Groundwater Application Review Summary Form

Application # G- 18855 (re-review)

TO: Water Rights Section Date 3/19/2021
 FROM: Groundwater Section Travis Brown
Reviewer's Name
 SUBJECT: Application G- 18855 (re-review) Supersedes review of 9/3/2019
Date of Review(s)

A. GENERAL INFORMATION: Applicant's Name: Siri and Sons Farms County: Clackamas

Well Location Map

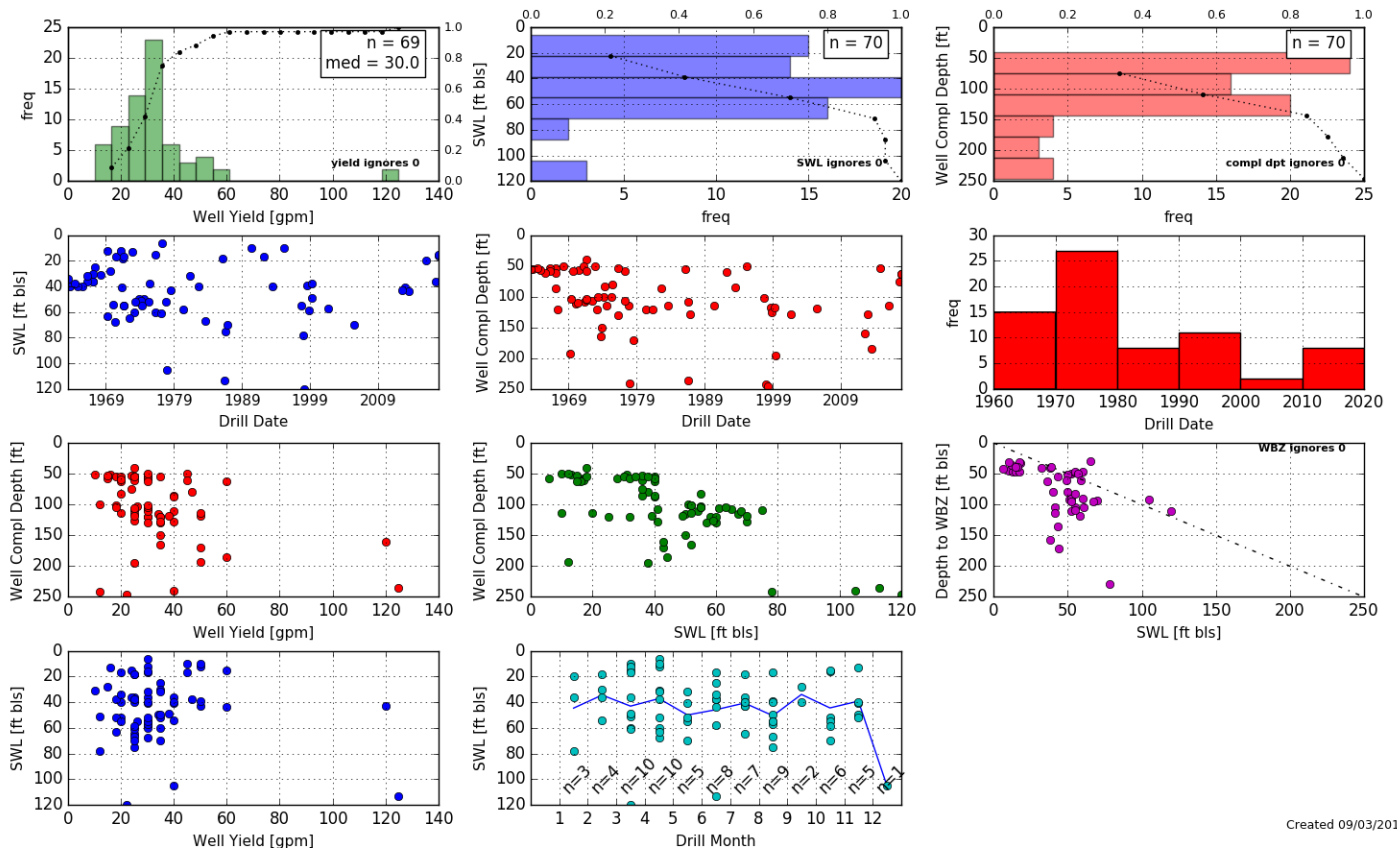
^a The applicant revised their proposed POA locations on March 18, 2021. The revised locations have been evaluated in this re-review. There appear to be discrepancies in the revised proposed POA locations provided in the application on the revised application map. The revised proposed POA locations described in the application by their distances from the center of Section 19 (metes and bounds) using the Department's Public Land Survey System (PLSS) projection are ~150-200 ft southwest of the locations indicated on the revised application map (using a copy of the map georeferenced to landmarks visible in aerial imagery county tax lot boundaries). The Applicant's described metes-and-bounds locations for POA 1 and 3 are outside the projected boundary of Clackamas County Tax Lot 311. However, the Department projection of Clackamas County Tax Lot boundaries were last updated in January 2019, and the Clackamas County Tax Lot boundaries available in the County's online mapping application (<http://cmap.clackamas.us/maps/cmap>) appear to have been updated again since then. The OWRD metes-and-bounds locations measurements of for the revised proposed POA using the georeferenced application map and the Department PLSS projection are listed in the table under A3 above. The OWRD locations will be used for this review.

Hydrographs

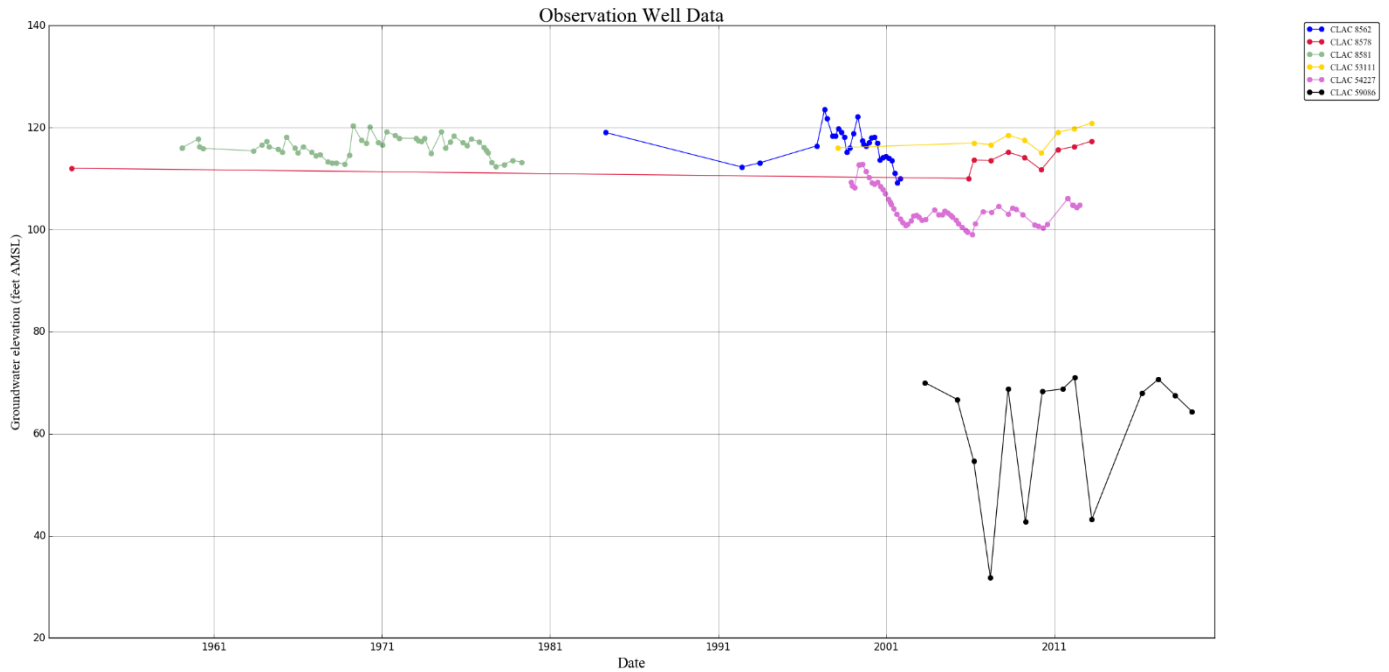
The nearest known groundwater right to the proposed POA is CLAC 73475, authorized POA under Permit G-17787 (priority 9/9/2003), ~~~350~~ 470 ft northeast of proposed POA 2. Due to the seemingly discontinuous nature of the water-bearing sands within the Willamette Confining Unit and a lack of high quality data with which to estimate hydraulic properties of the aquifer, it is difficult to anticipate how much the proposed use may interfere with nearby groundwater rights. Well completion statistics for other alluvial wells completed in Section 19 indicate a median well yield of ~30 gpm, with a maximum reported yield of 125 gpm (see Well Completion Statistics, attached). In order to achieve the total maximum rate requested (0.5 cfs), each of the proposed POA would need to yield ~75 gpm (~0.167 cfs), on average. While such a yield would represent ~250 percent of the median yield for wells in this area, it does not exceed the maximum reported yield (see Well Completion Statistics, attached). Water level data from the nearest observation wells (between ~0.7–2 miles south/southwest of the proposed POA) do not show widespread or persistent declines, although limited data is available through the present day (see Hydrograph, attached).

There is not sufficient evidence to conclude that the proposed use would likely result in injury to prior groundwater rights or would exceed the capacity of the groundwater resource. However, due to the potentially limited extent of water-bearing sands in the subject aquifer, the Conditions specified in B1(d) and B2(c) are strongly recommended for any permit issued pursuant to this application in order to protect senior users and the groundwater resource.
